ECR Title: Extraction of PSL beam in HAM1 through central viewport

DCC No: E1300676

Date: August 27, 2013

Figure 1: Current HAM1 design layout

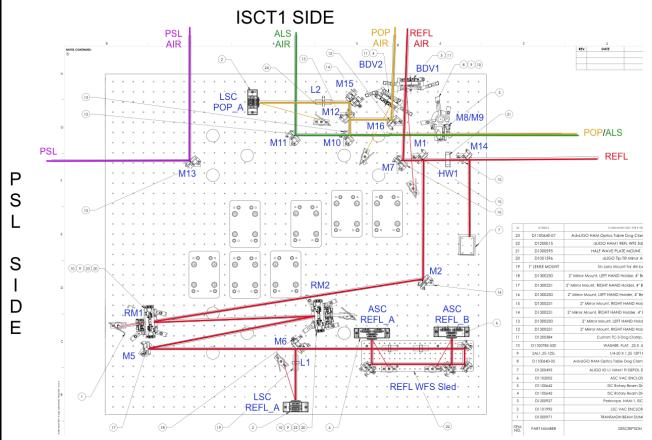
Description of Proposed Change(s): We propose to make a chance in the HAM1 design optical layout in order to extract the PSL beam through the central HAM1 viewport, and not through the viewport closest to the PSL as it is now (see figure 1 for the current drawing D1000313-v10). The goal is to have the PSL and ALS beams hitting the same spot on the top mirror of the ALS periscope on ISCT1. The angle between the two beams needs to be large enough to allow the two beams to hit two separate 2" mirrors by the time they reach the bottom of the periscope (the ISCT1 periscope height is 24").

Figure 2: Schematic of the proposed new layout.

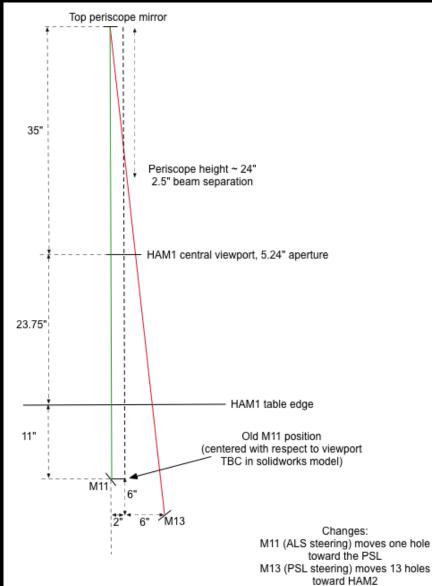
The ALS green beam steering mirror, M11, which now hits the center of the central viewport, will shift by 2" toward the PSL side, while the PSL steering mirror M13 will be moved by about 26" toward the HAM2 side. The beam dump for the LSC POP_A diode will be moved on the other side of the POP beam. A simplified scheme of the proposed changes are described in Figure 2.

The modifications in the ISCT1 layout (current version is: D1201103-v13) are:

- shift of the ALS periscope by 2" toward the PSL side
- replacement of top mirror (now a high reflector for 1064nm light) with a high reflector for both 532 and 1064 nm light
- additional 45 degree angled base plate to mount the bottom mirror of the periscope for the PSL beam
- removal of the PSL periscope
- shift of the ALS-M3 steering mirror about 20" toward the ALS periscope
